SERVICE BULLETIN

NO. 1242

Date: January 30, 2015

RUDDER PEDAL ASSEMBLY INSPECTION

Figure 1
Rudder Pedal Installation (Typical)

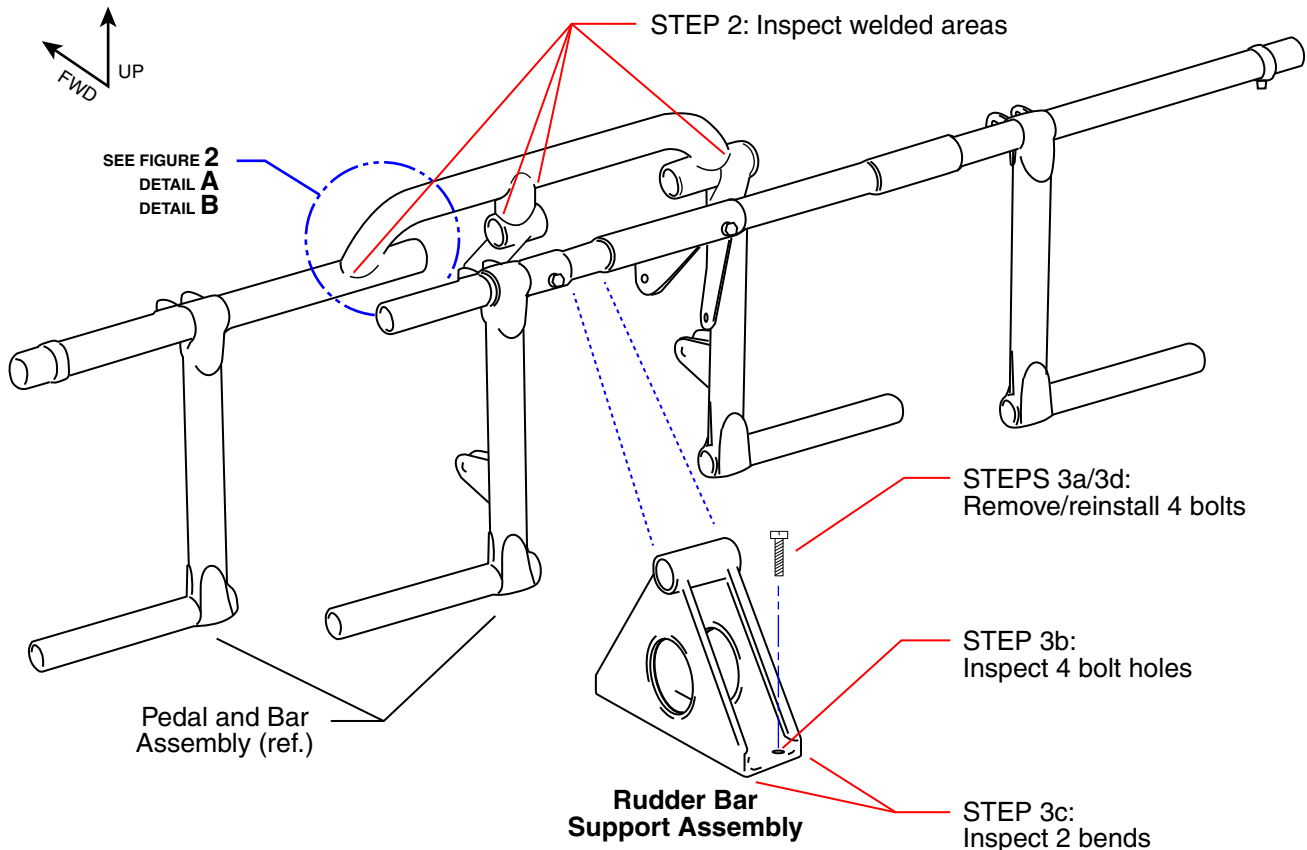
Visually inspect all welds, with specific emphasis on the locations identified in Figure 1.

- b. Visually inspect the four (4) bolt holes for cracks and elongation. See Figure 1. The diameter of the four bolt holes should measure 0.250 +0.005/-0.001 inches.
- c. Visually inspect the two (2) sheet metal bends common to the base for cracking, the entire length of each bend, both inner and outer surfaces. See Figure 1.
- d. Reinstall the four (4) bolts that secure the rudder bar support assembly to the cockpit floor. Refer to the appropriate section or chapter of the applicable Piper maintenance manual for the required installation torque for threaded fasteners.

Figure 2
Rudder Bar Welding (Typical)

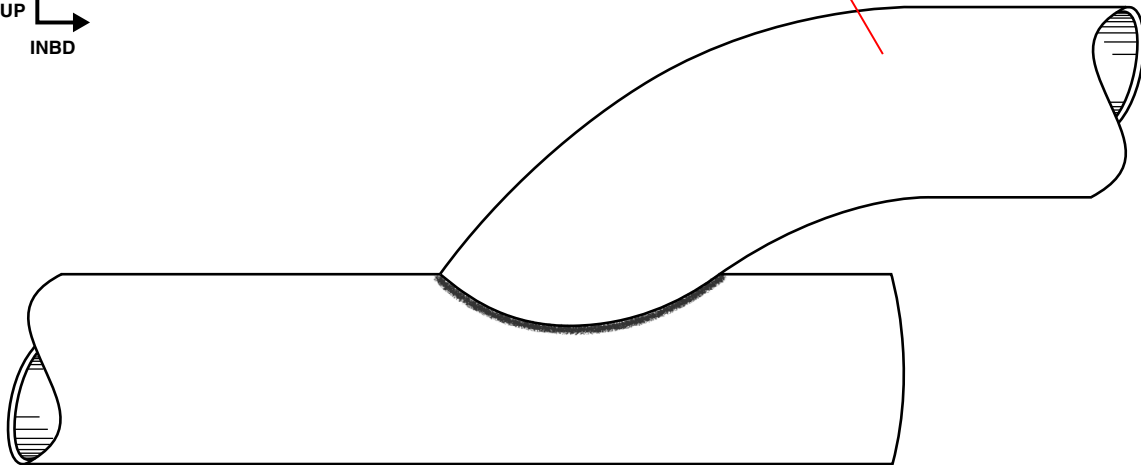
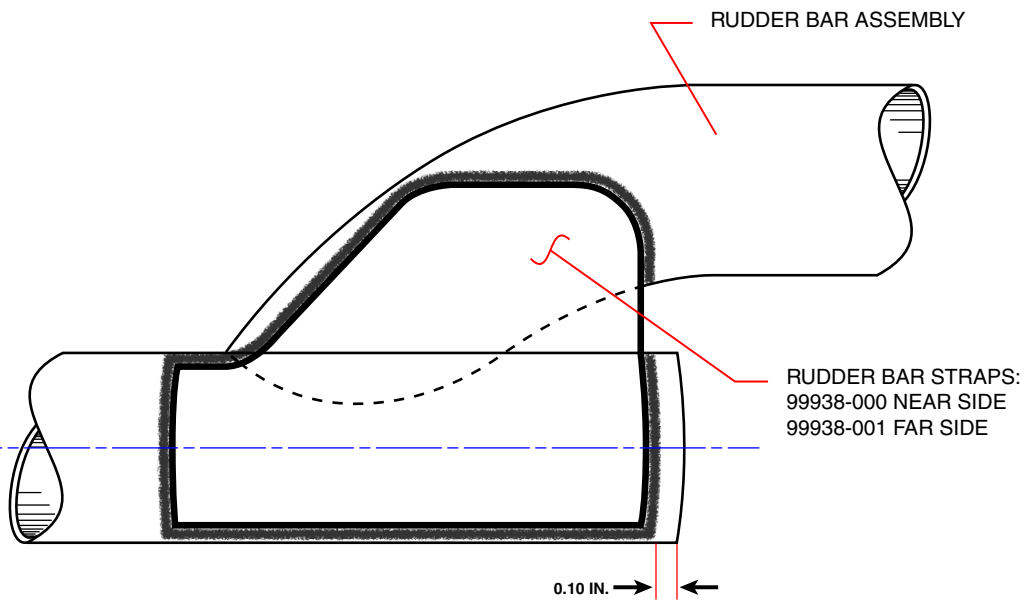
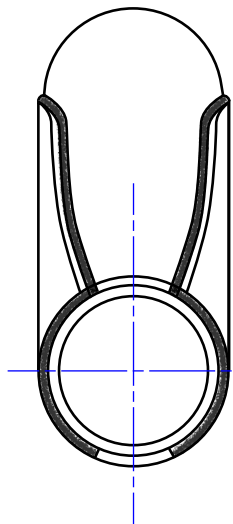
- Examine the area identified in Figures 1 and 2 to determine which rudder bar assembly configuration is installed on the airplane.
 - If the rudder bar assembly conforms to Figure 2, Detail B, the airplane is already in compliance with Service Letter (SL) 671, and/or a replacement rudder bar assembly has been installed which includes these features. No modification is required. Proceed to Part II.
 - If the rudder bar assembly conforms to Figure 2, Detail A, modification is required. Proceed to Step 2, below.

NOTE: All new replacement rudder bar assemblies conform to the configuration shown in Detail B. At the operator's discretion, a new replacement rudder bar assembly may be installed in lieu of the modification described below.

- Examine the area to be modified for cracks, using the inspection criteria described in Part II. Any cracked components must be replaced prior to proceeding.
- Order one each of Piper part numbers (P/N) 99938-000 and 99938-001 rudder bar straps. TIG weld in place as shown in Detail B, per Chapter 4 of AC 43.13-1B (or latest revision). After welding, relieve residual stress in the affected area: Heat with a non-carburizing torch flame to 1,000°–1,100° F (538°–593° C) (a brown red color) then air cool to room temperature. All welding must be performed by a certified welder.

- All materials are 4130 normalized steel.
- The rudder bar tubes have a nominal outside diameter of 0.875 inches and nominal wall thickness of 0.058 inches.
- P/N 99938-000 and 99938-001 rudder bar straps are made from sheet steel with a nominal thickness of 0.040 inches.
